134/23 ENU 6674

Rear Spoiler Control Unit Replacement - Follow Procedure (134/23)

Model Line:	Panamera (971)
Model Year:	As of 2017 up to 2020
Concerns:	Control unit for rear spoiler
Cause:	The previous rear spoiler control unit is no longer available for the Panamera (971 , model year 2017–2020). For this reason, the rear spoiler control unit for the Panamera (971 , from model year 2021) must be used if it requires replacement.
Action:	To facilitate installation and function of the rear spoiler control unit of the second generation Panamera in a first-generation Panamera, the rear lid wire harness and the rear spoiler wire harness must be adapted in the vehicle.
	Procedure:

Insulated line (example illustration)

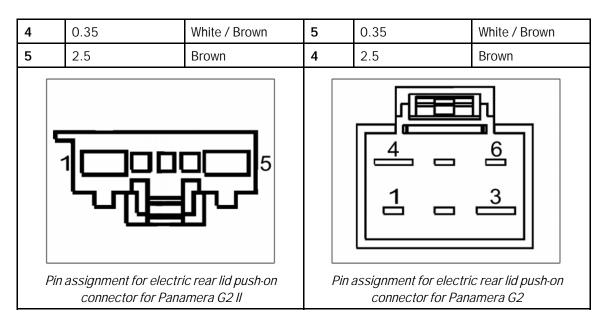
- 2.2 Prepare **previous** rear lid wire harness in the vehicle.
 - 2.2.1 Disconnect electrical line PIN 1 (red / white, 0.5 mm) on the vehicle rear lid wire harness and wear it watertight using a shrink-fit hose. The electrical line is no longer required. ⇒ Insulated line (example illustration)
- 2.3 In accordance with the following table, connect the new wire harness of the second-generation Panamera with the previous rear lid wire harness in the vehicle. Proceed with each line one-by-one as follows:

New rear lid wire harness for second- generation Panamera		Previous rear lid wire harness in the vehicle			
PIN	Cable cross- section in mm	Cable color	PIN	Cable cross- section in mm	Cable color
1	2.5	Red / Green	3	2.5	Red / Green
3	0.35	Brown / Red	2	0.35	Brown / Red

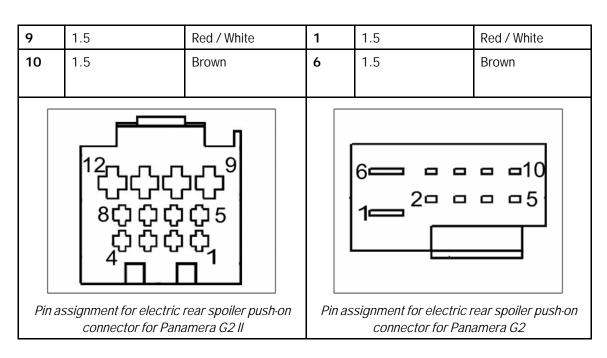
3.3 In accordance with the following table, connect the new wire harness of the secondgeneration Panamera with the existing rear spoiler wire harness in the vehicle. Proceed with each line one-by-one as follows:

The splice connection (connection point of two black electrical lines to a brown electrical line) remains on the vehicle-side wire harness PIN 2 (brown, 0.5 mm) and is crimped on the **brown** electrical line PIN 1 (brown, 0.5 mm) with the **new** rear spoiler wire harness of the second generation Panamera.

New rear spoiler wire harness for second- generation Panamera		Previous rear spoiler wire harness in the vehicle			
PIN	Cable cross- section in mm	Cable color	PIN	Cable cross- section in mm	Cable color
1	0.5	Brown	2	0.5	Brown
5	0.5	Red	5	0.5	Red
6	0.5	White	7	0.5	White
7	0.5	Black	4	0.5	Black

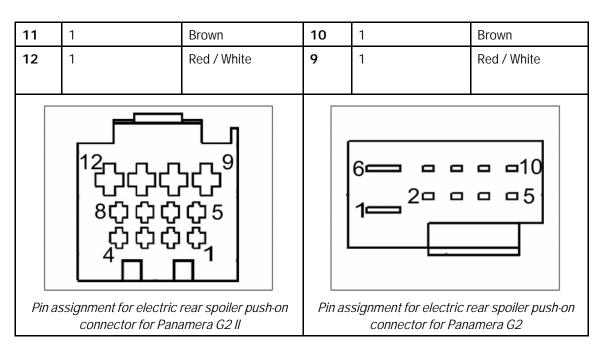
- 3.1 Prepare **new** rear spoiler wire harness for the second generation Panamera.
 - 3.1.1 Cut electric lines to different lengths (to allow for shrink-fit connections). Start at a length of approx. 200 mm/ 7.87 in and continue in the direction of the plug connection.
- 3.2 In accordance with the following table, connect the new wire harness of the secondgeneration Panamera with the existing rear spoiler wire harness in the vehicle. Proceed with each line one-by-one as follows:

The splice connection (connection point of two black electrical lines to a brown electrical line) remains on the vehicle-side wire harness PIN 2 (brown, 0.5 mm) and is crimped on the brown electrical line PIN 1 (brown, 0.5 mm) with the new rear spoiler wire harness of the second generation Panamera.

New rear spoiler wire harness for second- generation Panamera		Previous rear spoiler wire harness in the vehicle			
PIN	Cable cross- section in mm	Cable color	PIN	Cable cross- section in mm	Cable color
1	0.5	Brown	2	0.5	Brown
2	0.5	Brown / White	8	0.5	Brown / White
3	0.5	Brown / White	3	0.5	Brown / White
5	0.5	Red	5	0.5	Red
6	0.5	White	7	0.5	White
7	0.5	Black	4	0.5	Black
9	1.5	Red / White	1	1.5	Red / White
10	1.5	Brown	6	1.5	Brown
